## ADDENDUM #2

Reference: Roofing Improvements – Lightning Peak  
Division of Juvenile Justice Services – Provo, Utah  
DFCM Project No. 07152430

Subject: **Addendum No. 2**

AD101

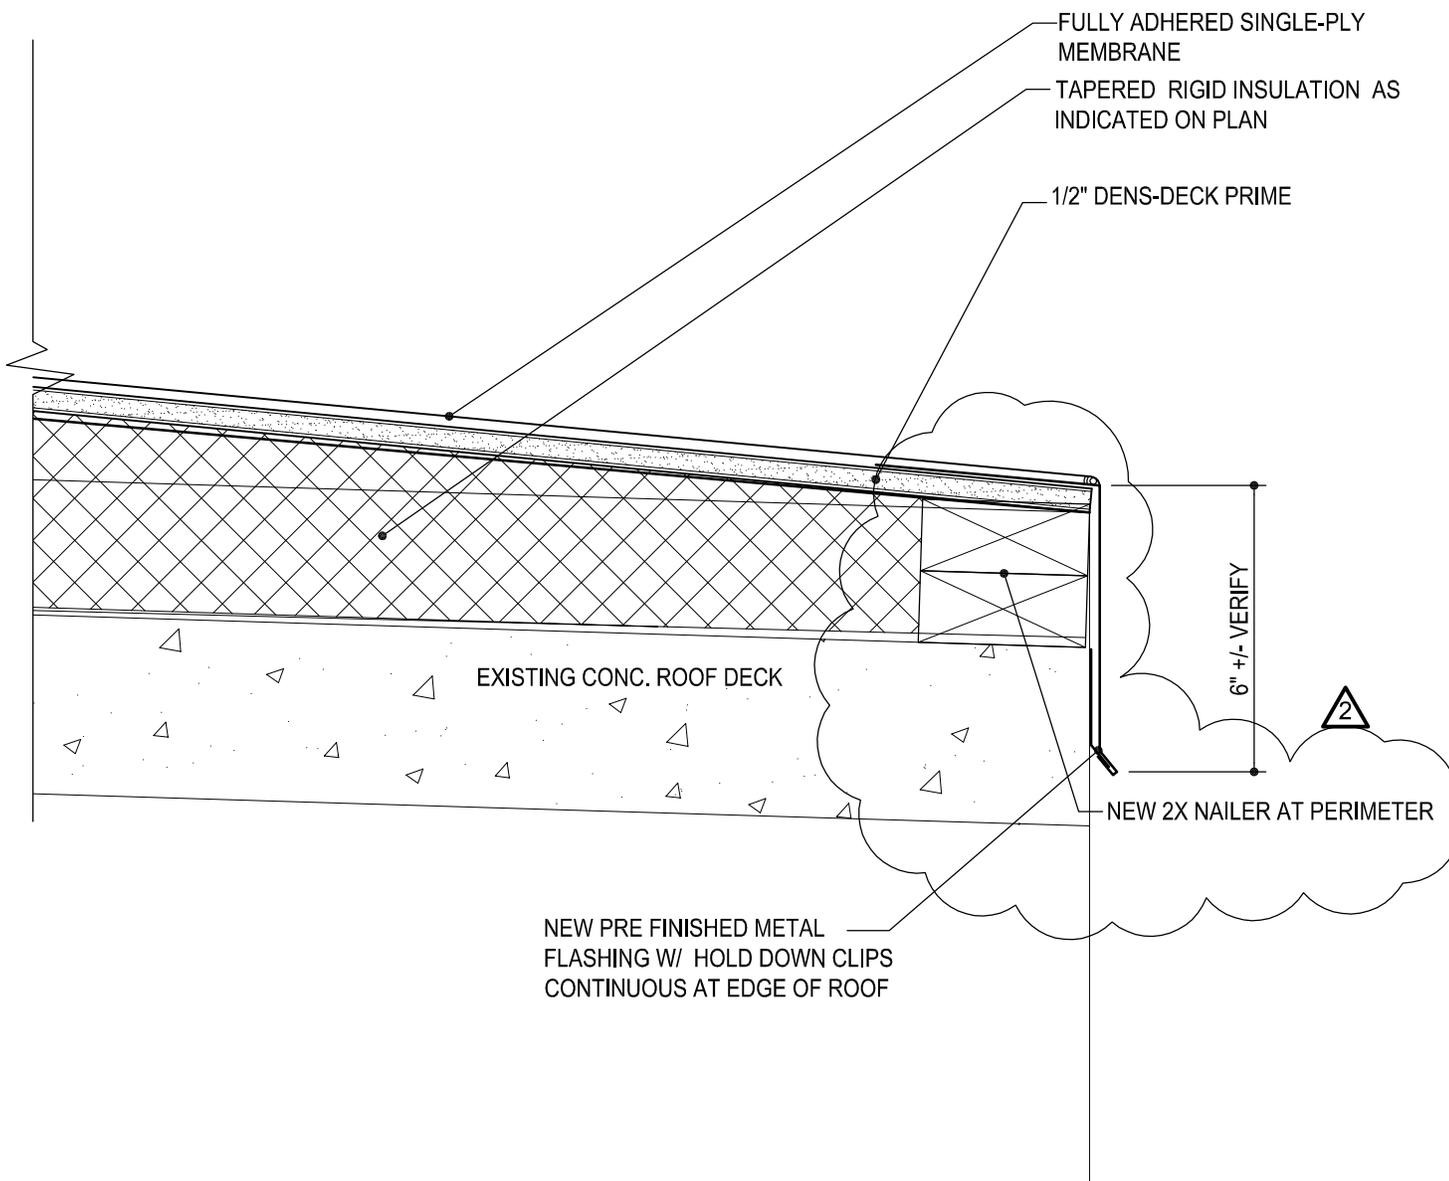
- Sheet AD101 increased amount of area of the existing roof system to be demolished down to existing roof deck. See attached revised drawing AD101.

# RF-01

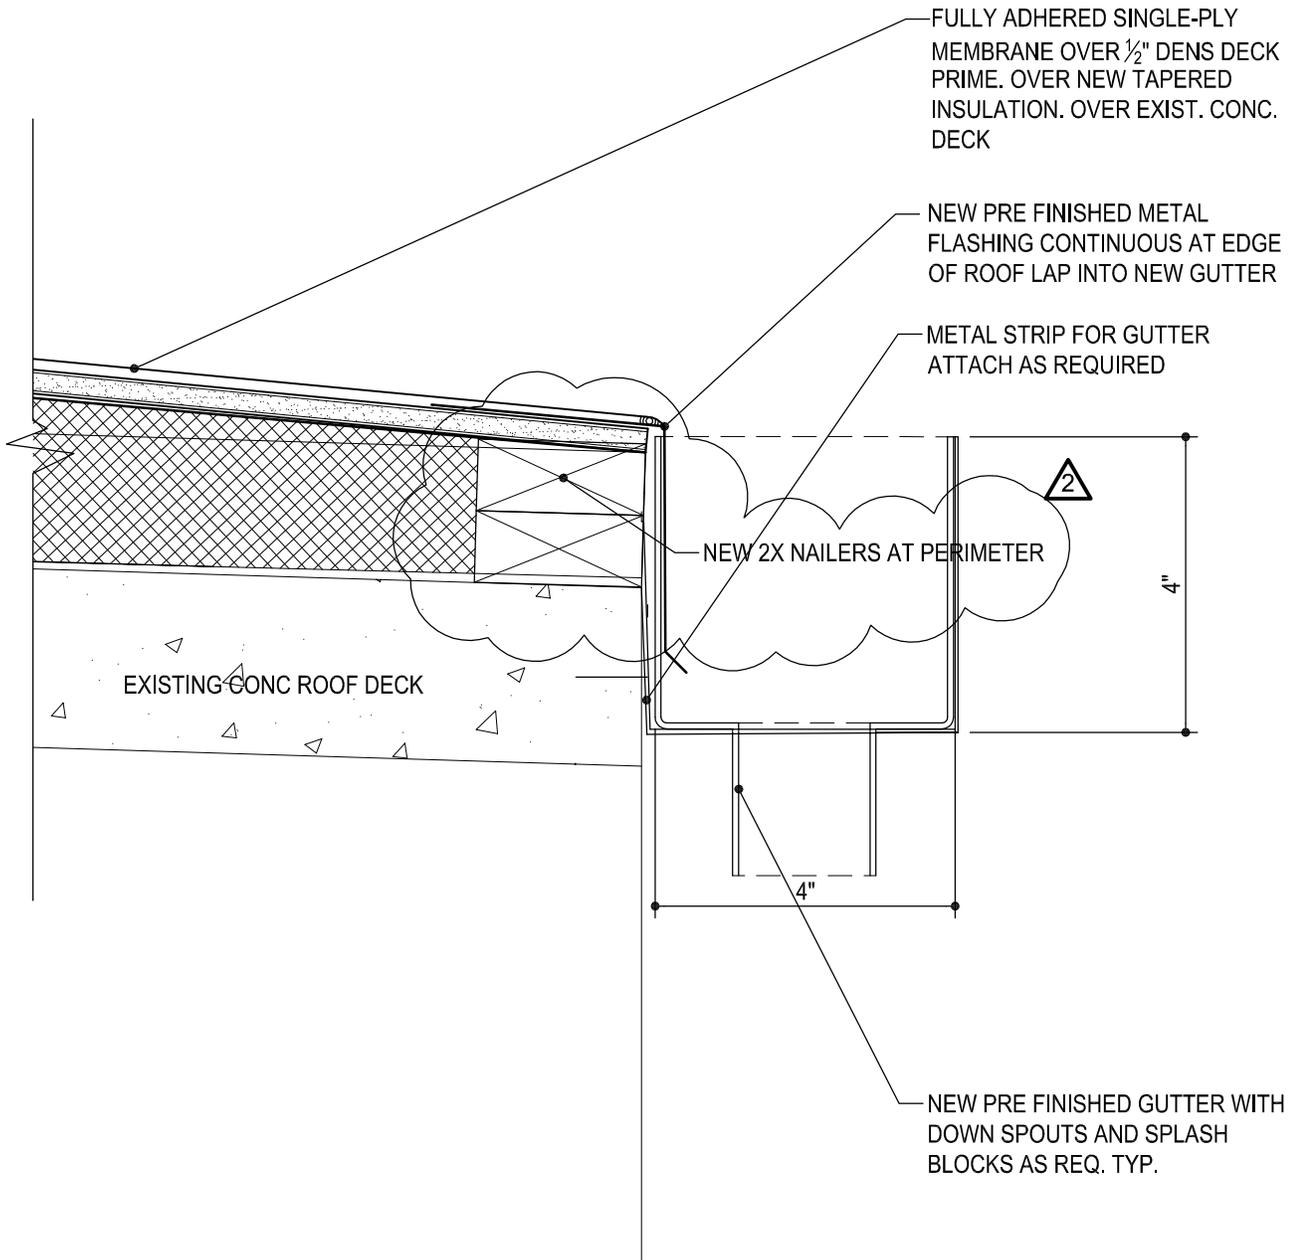
- Revise detail RF-01. See attached revised detail RF-01 Roof Edge Detail
- Revise detail RF-05. See attached revised detail RF-05 New Gutter @ Roof Edge Detail
- Revise detail RF-07. See attached revised detail RF-07 Roof Edge & Gutter Detail
- Revise detail RF-09. See attached revised detail RF-09 Roof Edge Detail
